BURLINGTON DEVELOPMENT REVIEW BOARD

Tuesday April 21, 2015

- 2. 15-0801PD; 140 Grove St (RL, Ward 1) Ireland Grove Street Properties**
Final plat review of PUD to demolish existing concrete plant and buildings, construct 19 new buildings for 232 residential units, clubhouse, and maintenance building with associated road, parking, and site improvements (Project Manager, Scott Gustin)

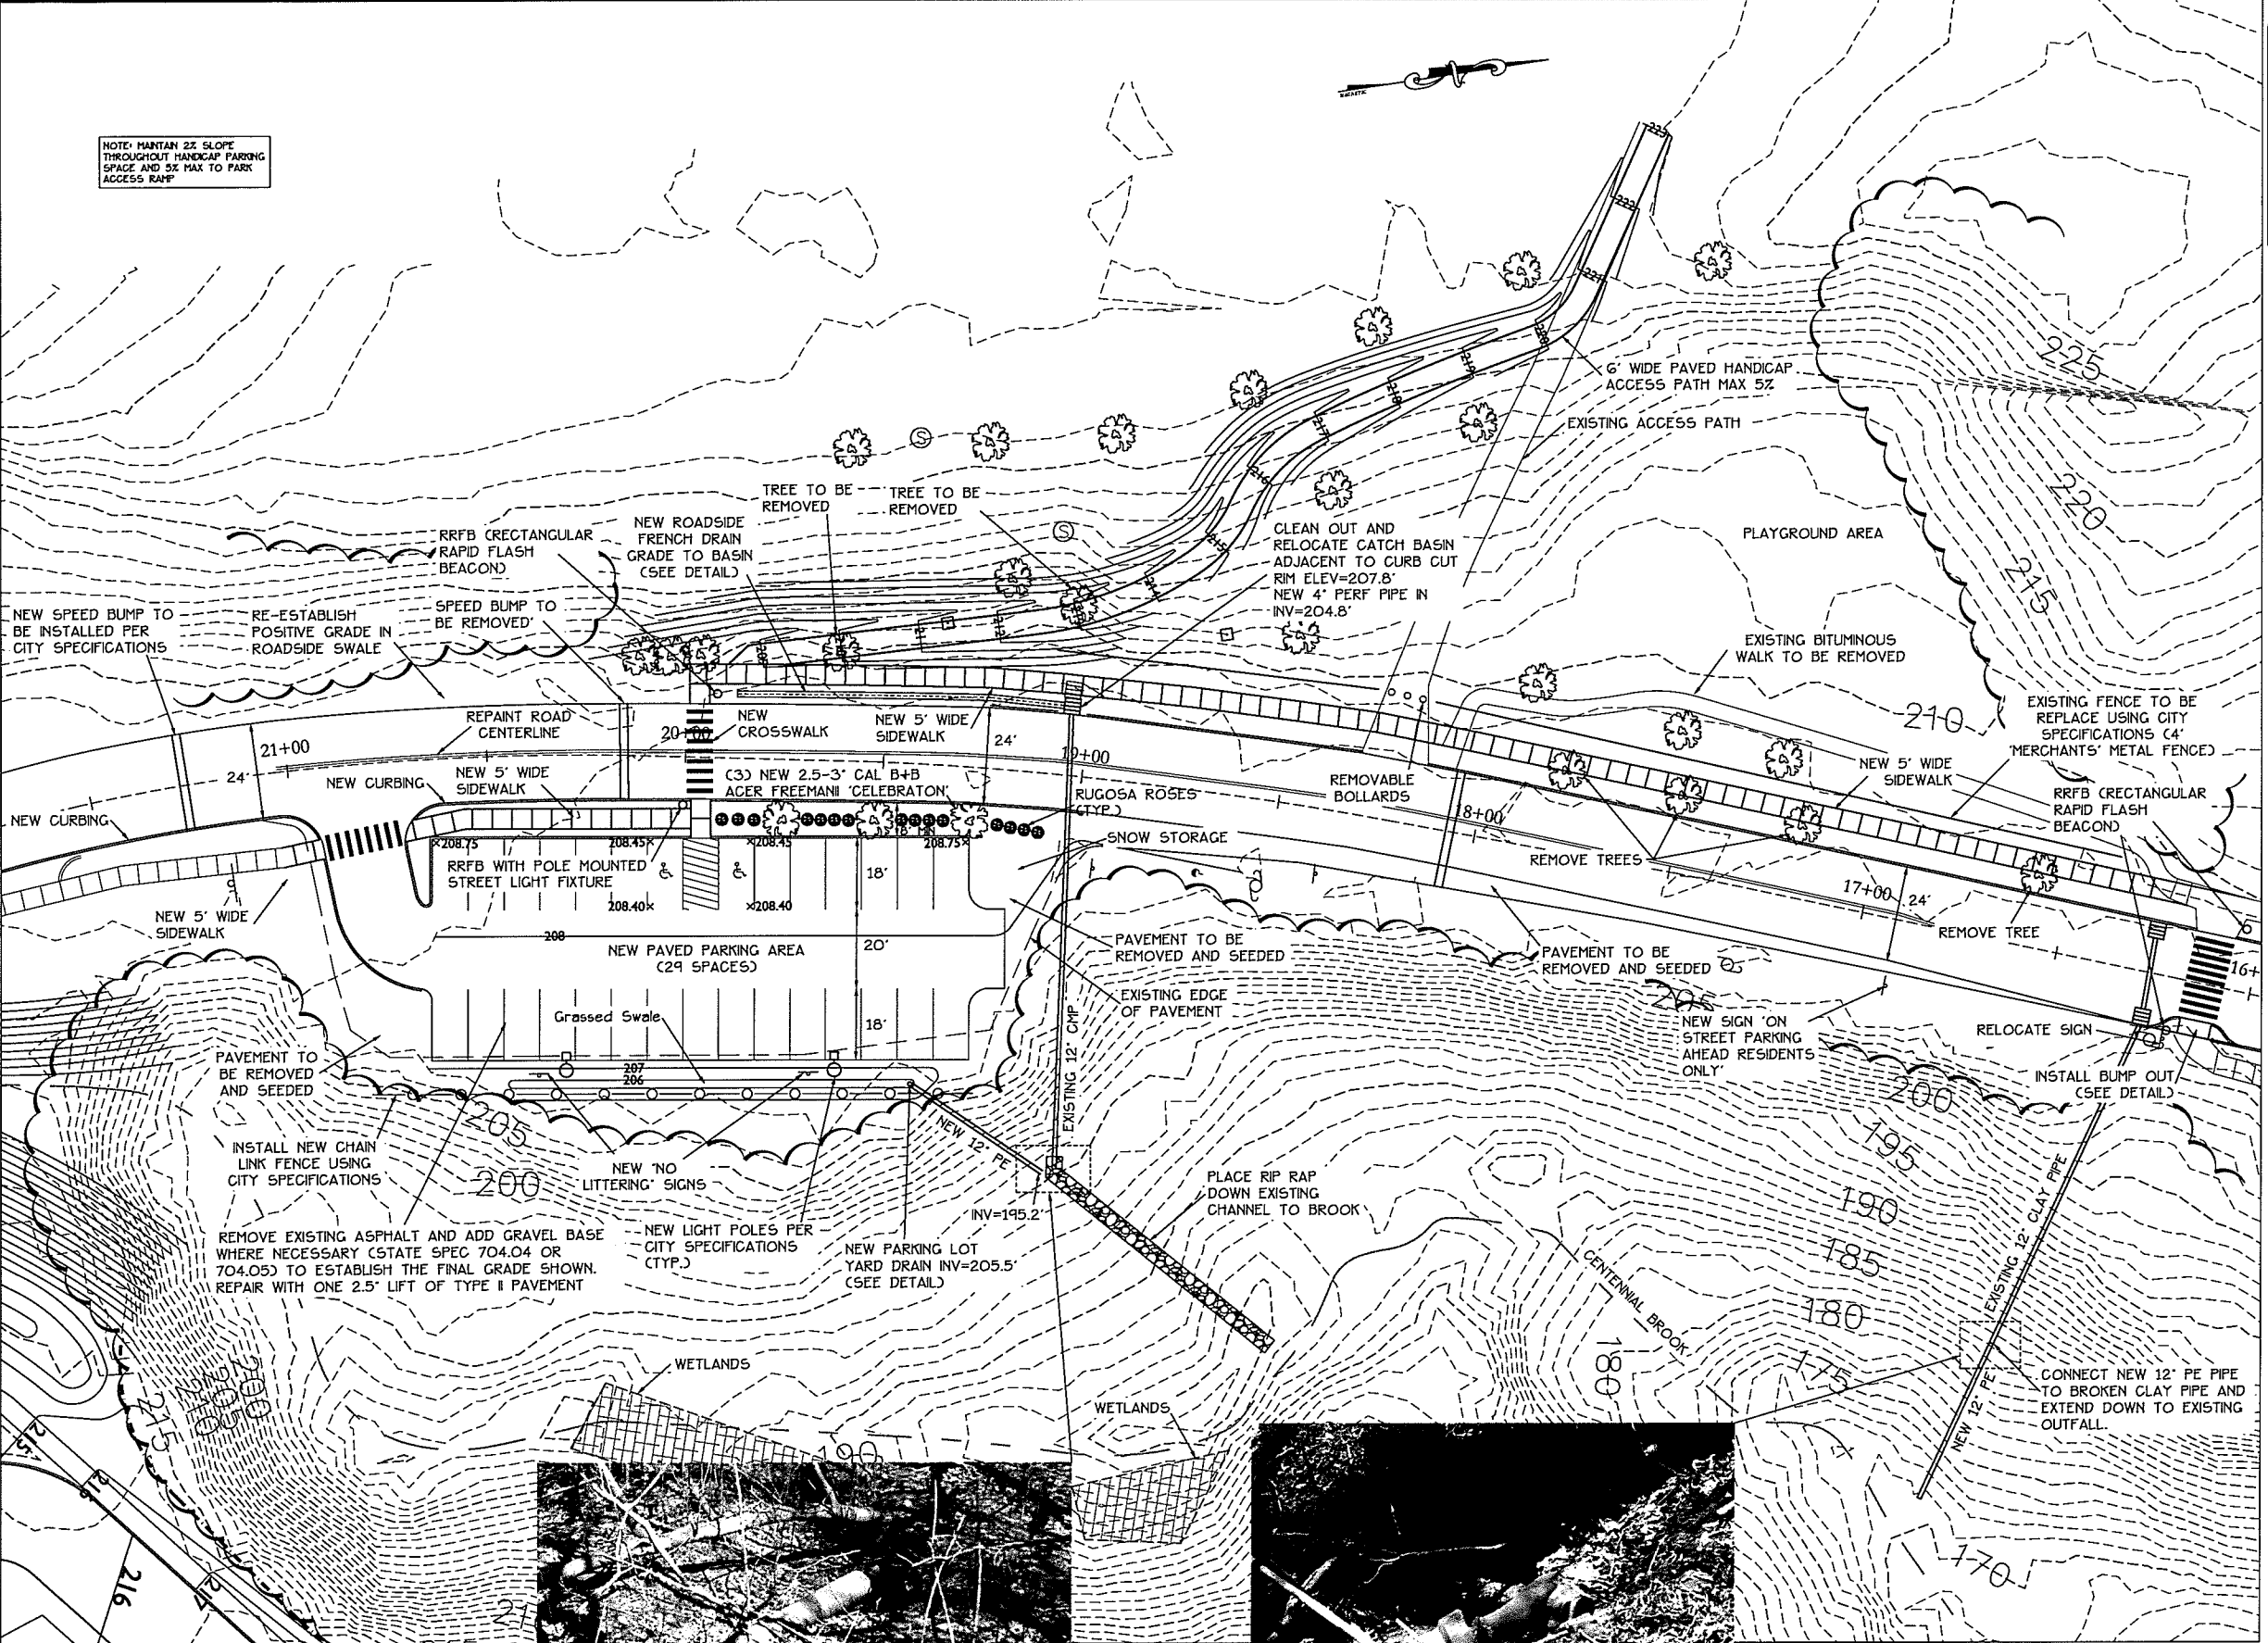
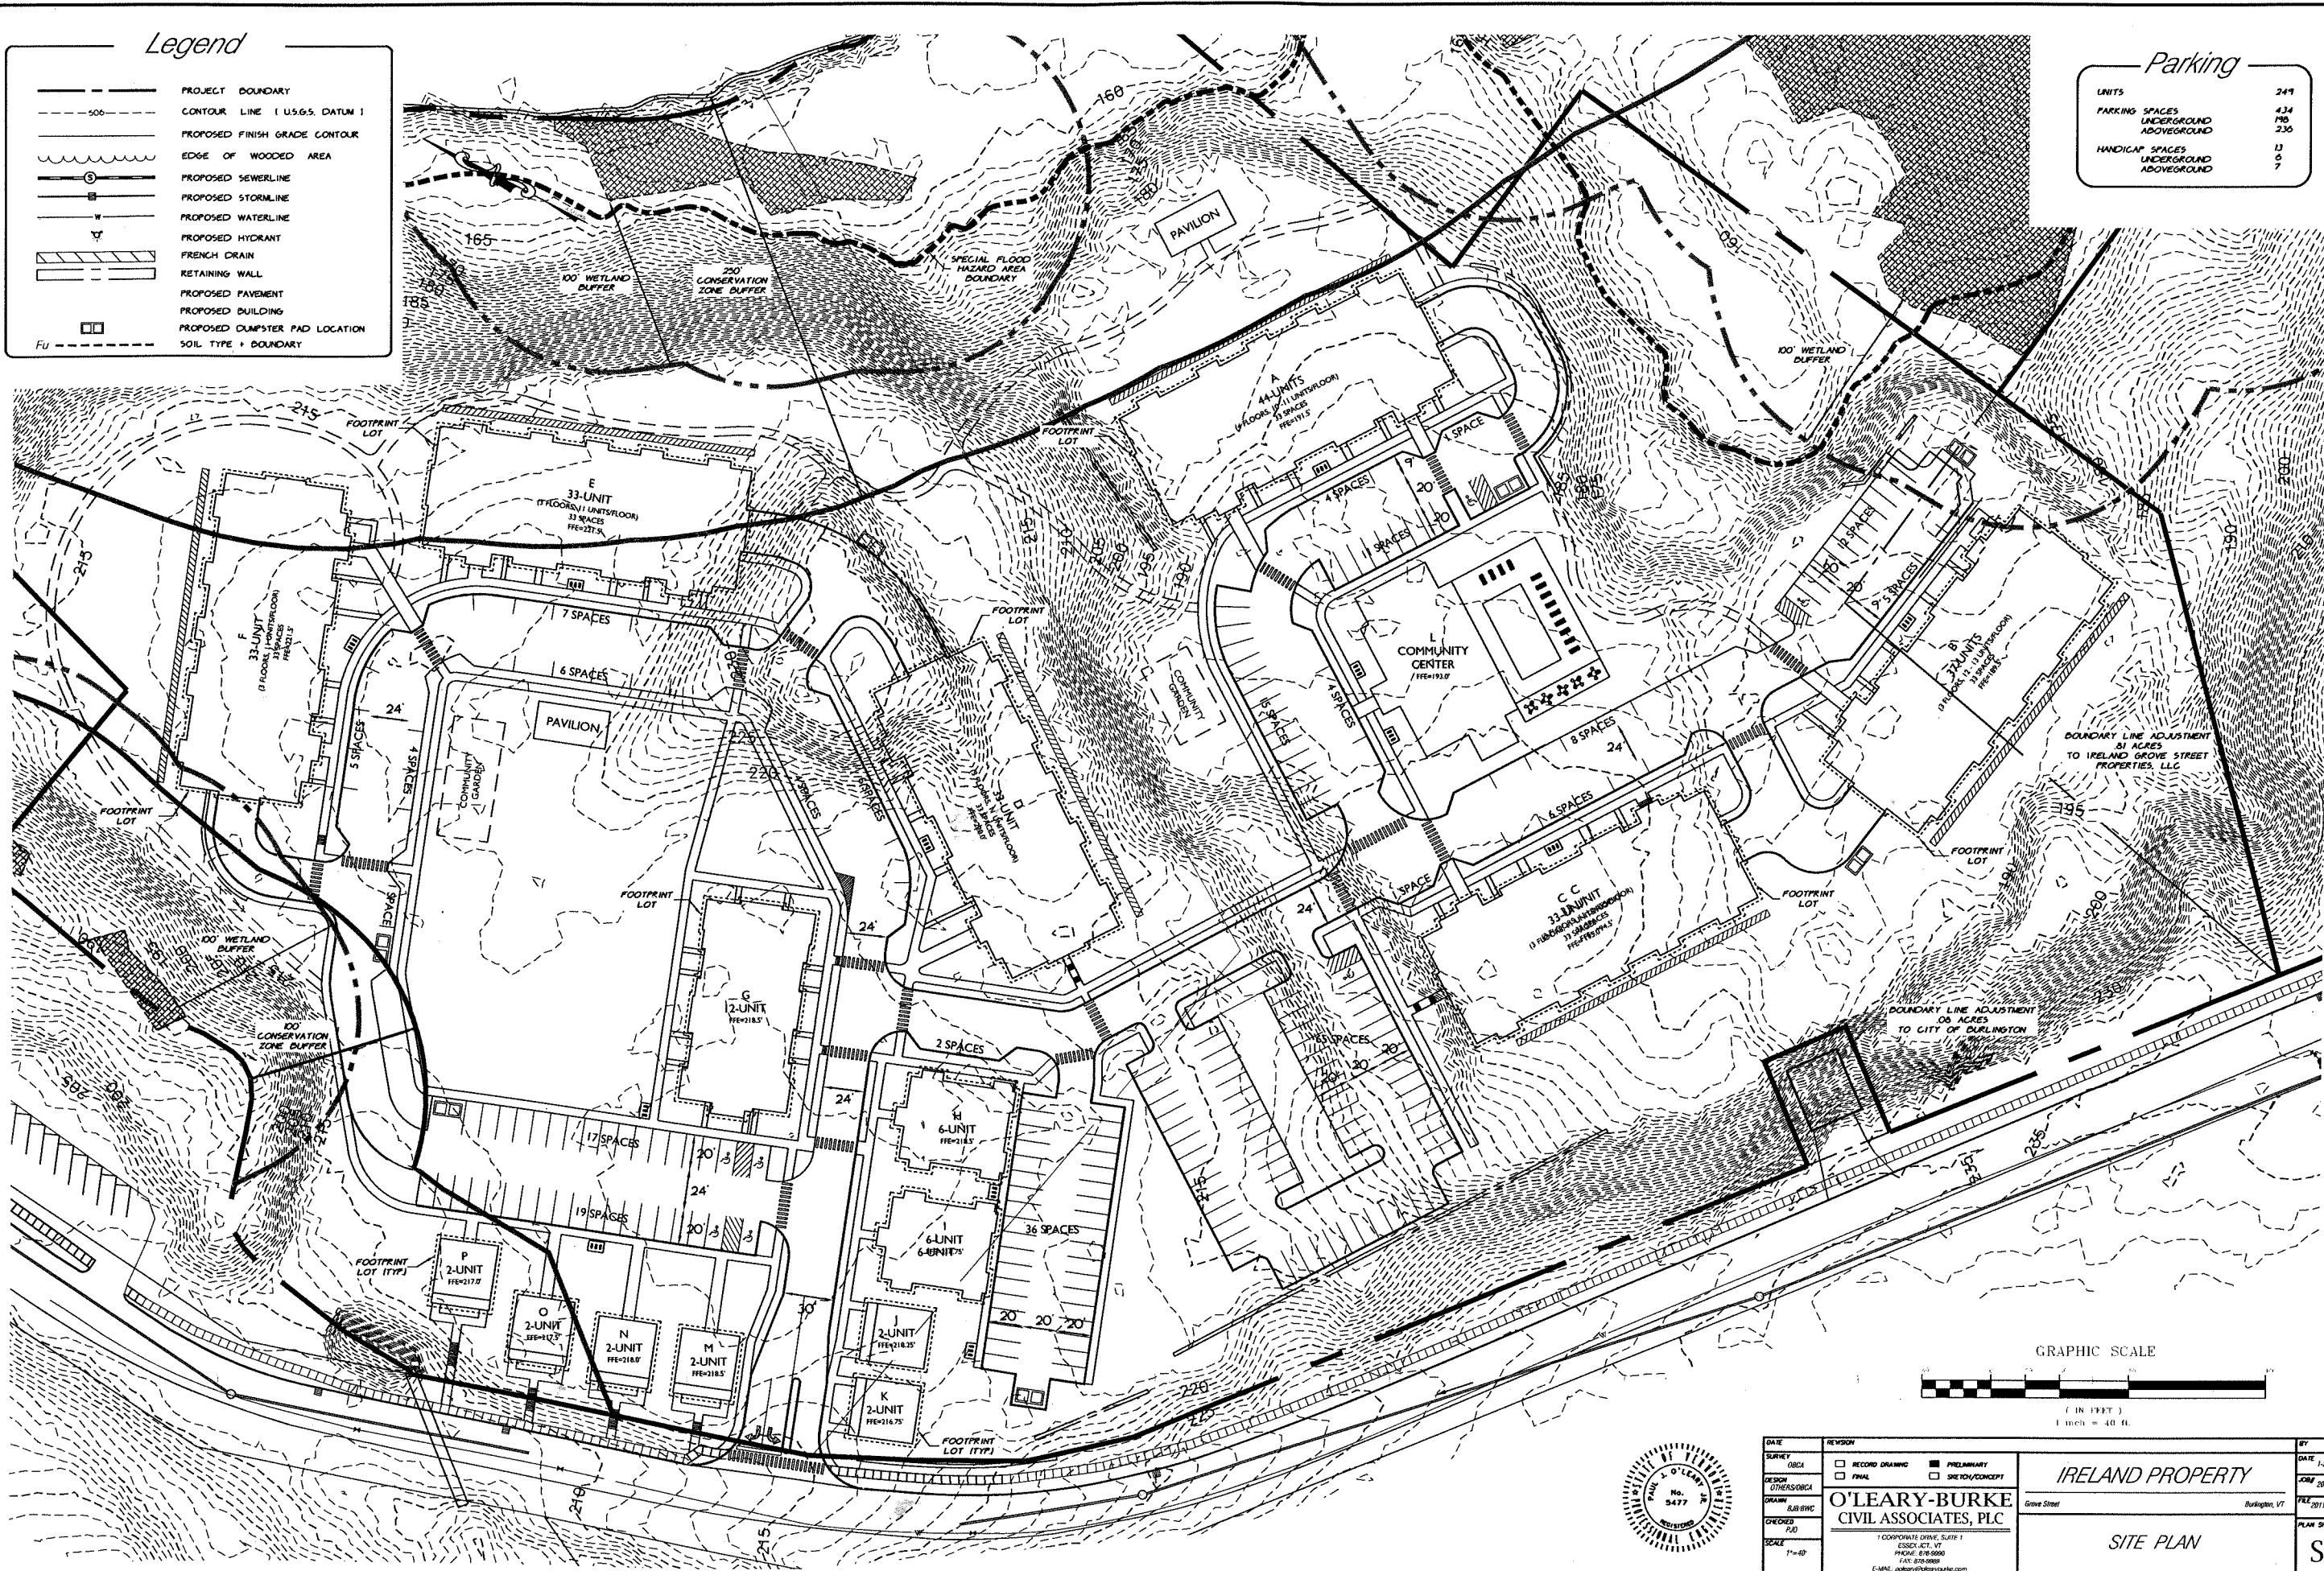
On sheet S8 'The park and parking lot', we will move/transplant the young tree that's currently in the way of the new proposed path. The one we planted this spring. The three trees proposed for the parking lot redesign shall be specified on the sheet/plans as: 2.5"-3" caliper B&B Acer freemanii 'Celebration'.

2. **Sheet S8: Speed bump removal and relocation: specification of new speed bump design is not provided for review.** This department approves the current "speed table" design as utilized in other City projects and as provided previously by the Department of Public Works Engineering Department.

We discussed changes on plan sheet S8 to the parking lot area and adjustments to the pedestrian path and crossing the parking lot. Jen provided details and specifications for the Parking lot lights that need to be included in the plans. I also provided grass seed mix specifications to be included on plan sheet S15.
